Urgent Field Safety Notice

Deep Brain Stimulation (DBS™) Lead Kits: Models 3387, 3387S, 3389, 3389S, 3391, 3391S

Potential Lead Damage Associated with the DBS Lead Cap: modified instructions

Medtronic reference: FA565

Additional Instructions for Capping the Lead

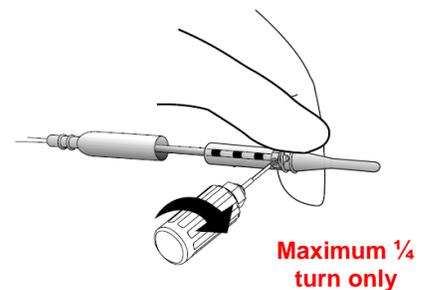
Follow the instructions in the Implant Manual for capping the lead, *with the exception of* Step 4 and Step 5 (regarding how the setscrew connector block should be held, and tightening the setscrew until clicks are heard), which should be modified as follows:

Regarding Step 4:

Any time you use the torque wrench, hold the setscrew connector block firmly between the thumb and forefinger to prevent rotation of the block.

Regarding Step 5:

Tighten the single setscrew in the setscrew socket on the number 3 lead contact by turning it clockwise with the torque wrench provided. **Tighten the setscrew until it touches the contact; then continue tightening for a maximum of ¼ turn only (you may or may not hear the sound of a click).**
